RE: PROPOSED MIXED USE DEVELOPMENT
HUNTER STREET, PARRAMATTA

1. As we have reviewed the traffic effects of the amendments to the above development as part of the Preferred Planning Report (PPR). With respect to traffic the following amendments have been made:

8.8m MEDIUM RIGID VEHICLE SWEPT PATHS

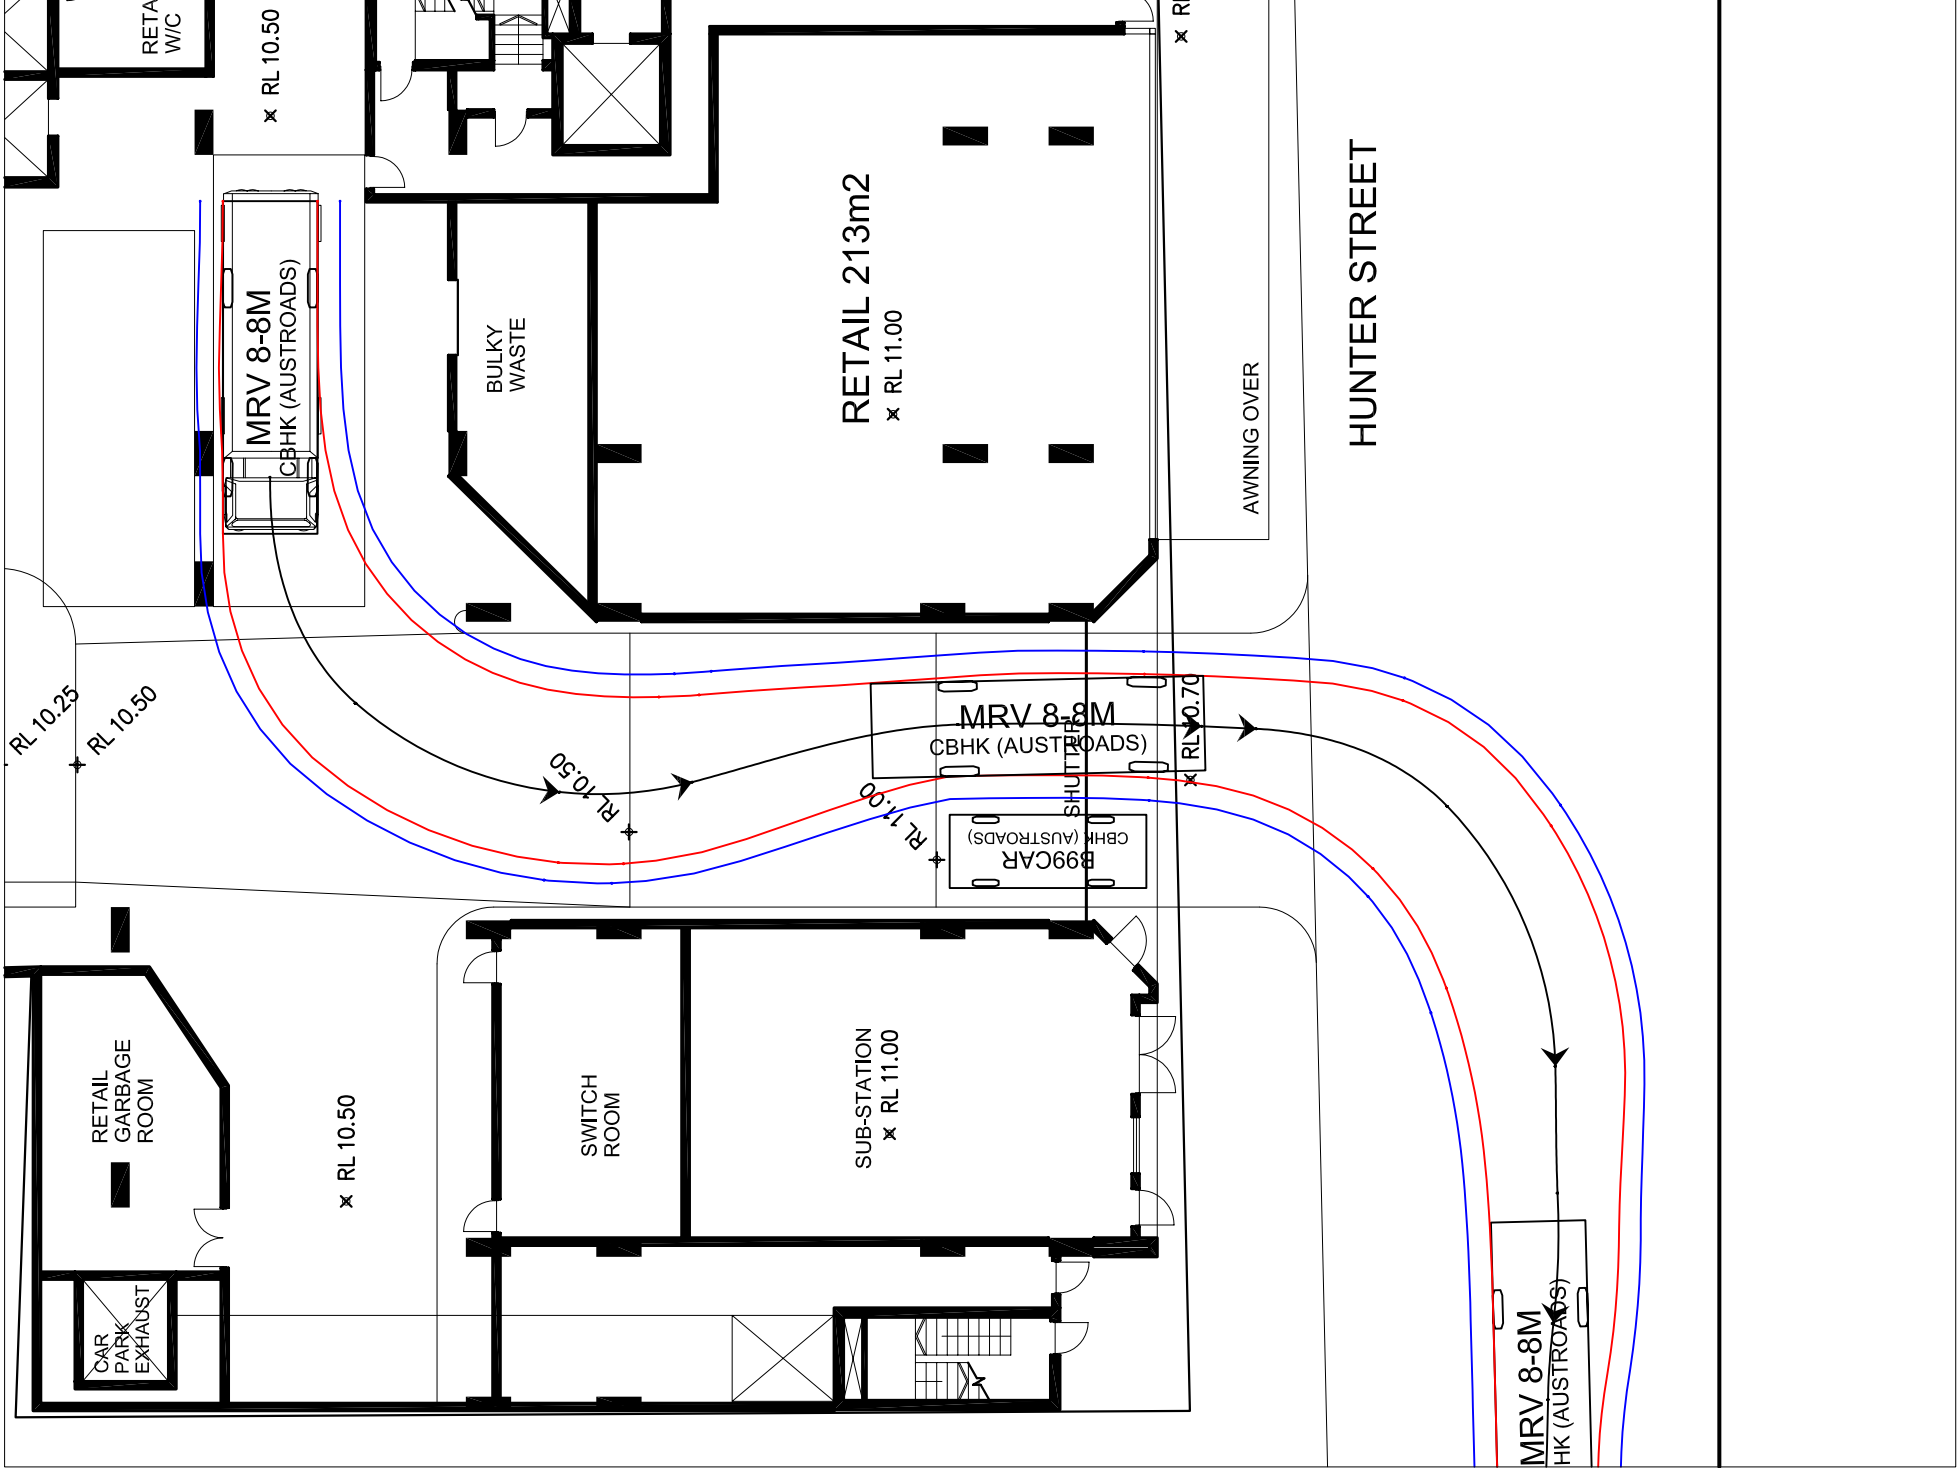
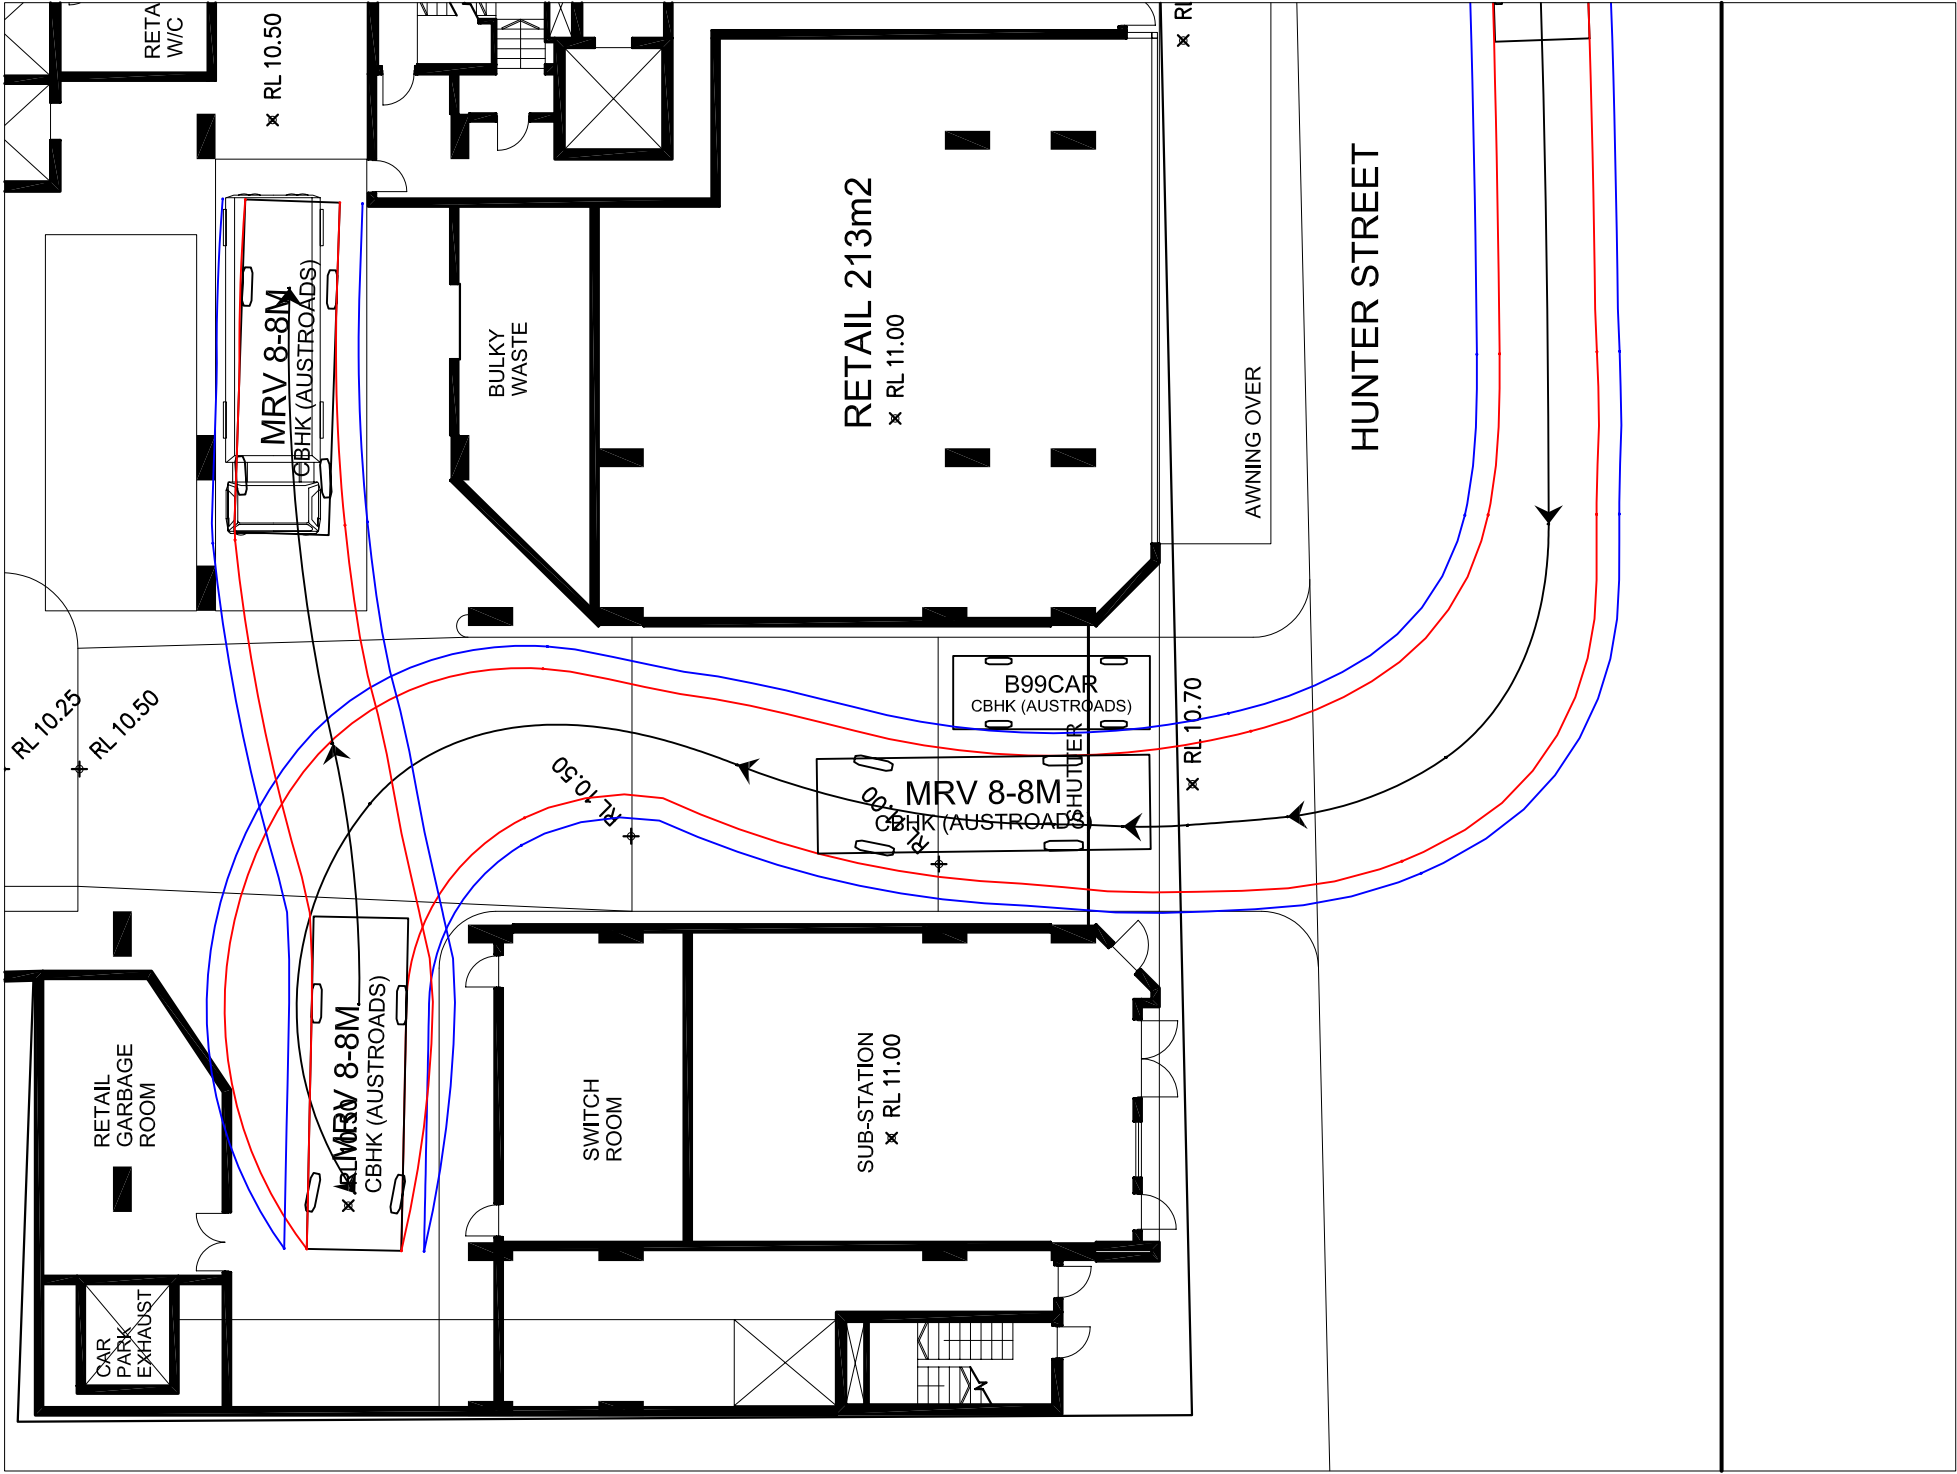
10. Swept paths of an 8.8 metre long medium rigid truck (MRV) accessing the loading dock are shown in the attached Figure I. Some minor modifications are required to the layout of the loading dock (splaying of garbage room and relocation of column to south dock by about a metre) to allow access by an MRV. These could be addressed through a condition of consent.
